Baldon Wind Farm SSD-40138508

Submissions Report

Document No.: BWF-PM-REP-0024

Revision Date: May 2025

Figure 1-2 Baldon Wind Farm general layout

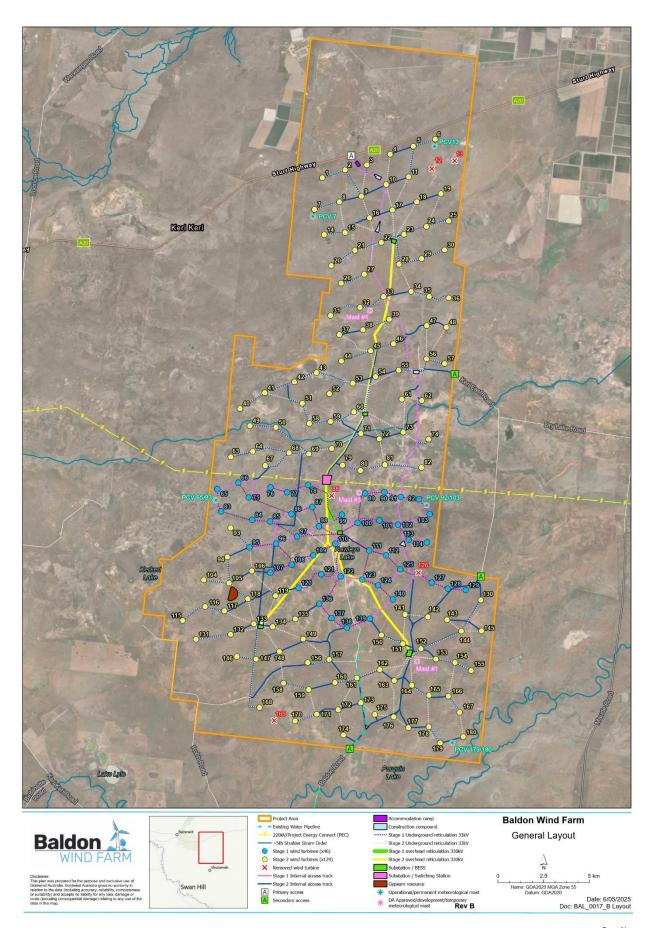
Comments	or issues raised by DPHI Planning	Pro	ponent Response	
10 Decemb	10 December 2024 RFI			
on the prop	ment requests further information bosed workforce accommodation. Wide or confirm the below	 a. As described at Section 3.3.10 and shown on the Site Lay drawing (Figure 1-2), the on-site workforce accommodate camp is proposed within the Project Area assessed by the approximately 200 m from the Sturt Highway within the providing easy access and evacuation. A detailed camp lay would be designed prior to construction (if the Project staccommodation camp option is pursued) and will consider Project staging. b. As per the Site Layout drawing (Figure 1-2), the primary point to the Project area (including the on-site workforce accommodation camp) will be directly from the Sturt Highway within the Secondary site accesses from Baldon Road in the south as 	drawing (Figure 1-2), the on-site workforce accommodation camp is proposed within the Project Area assessed by the EIS,

- b. The EIS assessed an area for the on-site workforce accommodation camp (refer to Figure 1-2 of this Scoping Report) that is sufficient for all parking requirements. All parking would be within the EIS construction footprint and no parking would be permitted along Sturt Hwy.

- d. Internal access roads are shown on the Site Layout drawing (Figure 1-2). As described at Section 3.3.7 (Project description) and 7.2.6 (bushfire assessment) of the EIS, internal access roads, including those to the on-site workforce accommodation camp, would be two-wheel drive, all-weather roads built to withstand Over Size Over Mass (OSOM) heavy vehicles, bushfire fighting tankers and fleet of concrete agitator trucks and other construction plant. The site roads would be suitable for workforce accommodation traffic that will be mainly entering and leaving site using less than 1 km of access tracks.

Figure 3-1 Baldon Wind Farm – Project refinements

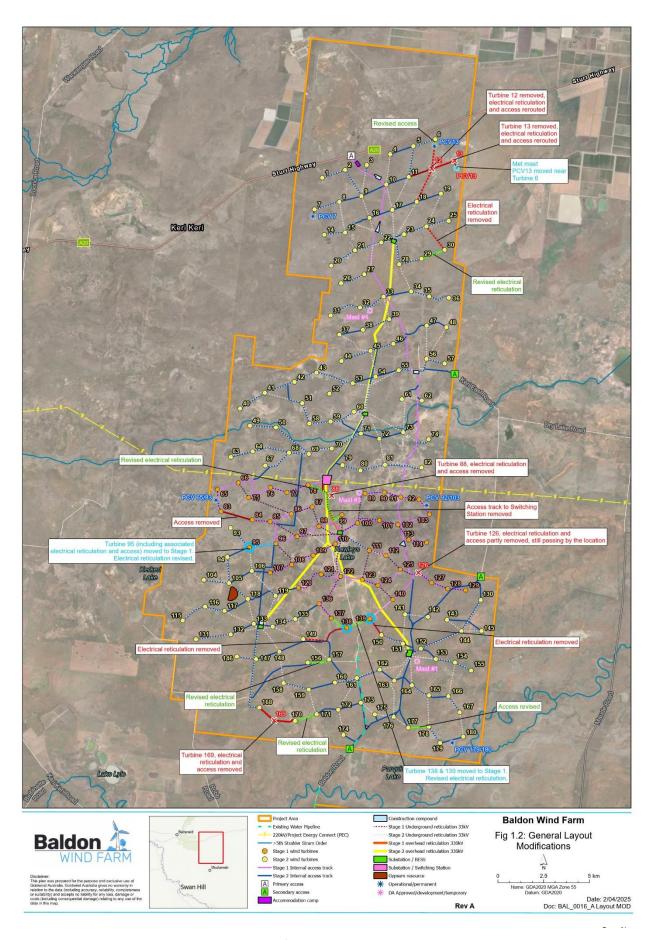
The Project refinements fit within the limits set by the EIS Project description and do not change the fundamental development consent application. The Project refinements include the following aspects, which are shown on Figure 3-1.

Figure 3-2 Primary Project transport route – Port Adelaide to Project Area

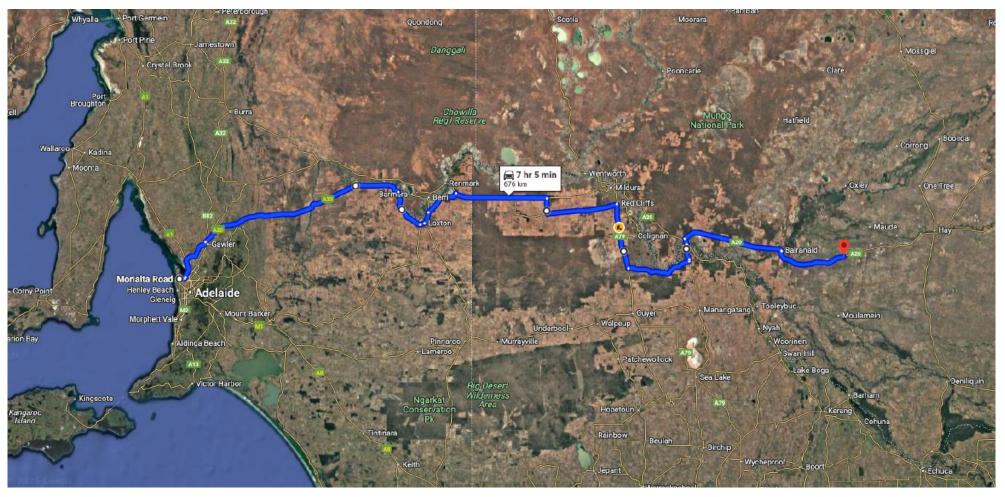
- j. As per the updated Route Study and updated TIA, the Project no longer proposes to use the route from Port of Newcastle and proposes to use the route from Port Adelaide only. Also, with the exception of an alternative route between Port Adelaide and Moorook South in South Australia (~210 km) for high loads, a single route is now proposed from Port Adelaide to the Project, rather than the four Port Adelaide route options presented with the EIS (refer to Figure 3-2).

As per the updated Route Study and updated TIA, the Project no longer proposes to use the route from Port of Newcastle and proposes to use the route from Port Adelaide only. And, with the exception of an alternative route between Port Adelaide and Moorook South in South Australia (~210 km) for high loads, a single route is now proposed from Port Adelaide to the Project, rather than the four Port Adelaide route options presented within the EIS (refer to Figure 3-2).

Project Refinements: Deleting WTGs 12, 13 and 88

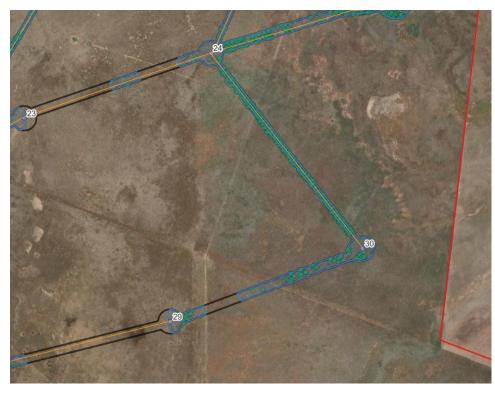
Remove WTG 12 & 13 and associated roads & reticulation. Due to flood study results

Remove WTG 88and associated roads & reticulation. Due to flood study results
